**Independent Hearing
And Assessment
Panel Meeting**

3 April 2017 – 6.00pm

ITEM 1	29 Anderson Street, Belmore
	Demolition of existing dwelling house and construction of a two storey boarding house consisting of 18 boarding rooms
FILE	DA-279/2015
ZONING	R3 Medium Density under Canterbury LEP 2012
DATE OF LODGEMENT	29 June 2015 (amended plans received 22 December 2015, 6 June 2016, 1 December 2016 and 7 March 2017)
APPLICANT	Mr R R Jenvey
OWNERS	Mr R R Jenvey
ESTIMATED VALUE	\$945,000
SITE AREA	1,011.7m²
AUTHOR	Planning

ITEM 2	9-11 Weyland Street, Punchbowl
	Demolish existing structures, consolidation of both lots into one and construction of a six-storey mixed use development comprising 42 apartments, two commercial tenancies, two level basement for parking and associated landscaping
FILE	DA-632/2015
ZONING	B5 Business Development under Canterbury LEP 2012
DATE OF LODGEMENT	21 December 2015 (amended plans received 20 December 2016)
APPLICANT	E Fox
OWNER	Gejo Pty Ltd
ESTIMATED VALUE	\$9,983,058
SITE AREA	1,040m²
AUTHOR	Planning

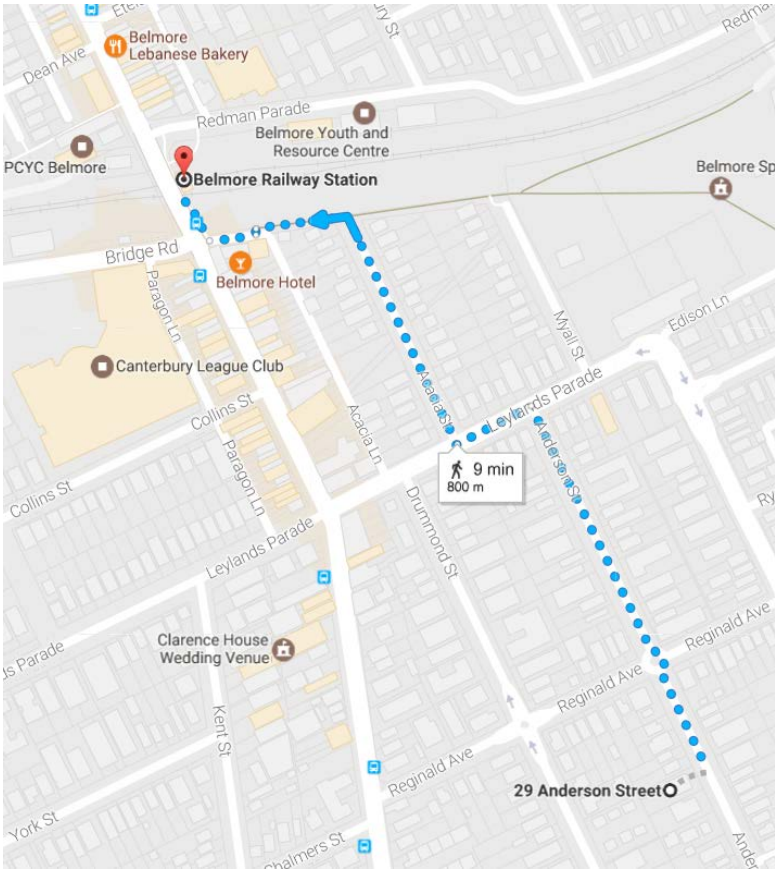
The design of the compound is contrary to Council's controls for new development pursuant to Canterbury Development Control Plan (CDCP) 2012 which does not permit permanent waste storage areas in the front of a site where they would be visible from the public domain and also does not permit fencing higher than 1.2m in the frontage.

The applicant has suggested that the proposal is compatible with the streetscape, presumably as existing older residential flat buildings have similar compounds such as the flats at 31 and 40 Anderson Street. This is not acceptable or reasonable since the proposal is a new development and more importantly is designed in 2017 and is not a 1970s residential flat building. In this regard, the proposal should not be compared to 1970s flats built under superseded controls and should contribute to the desired character that is being achieved by all other new developments. If the development were to be approved in its current form, it would set a poor example and precedent for other new developments within this streetscape to also locate waste storage within their front setback. For this reason, it is recommended that the waste area be relocated out of the front setback, by way of a deferred commencement condition.

- b) The waste storage compound located within the front landscaped setback must be relocated behind the building line. The compound should be located away from windows to reduce noise and odour nuisances. (Refer to Canterbury Development Control Plan 2012 for additional controls which must be complied with).
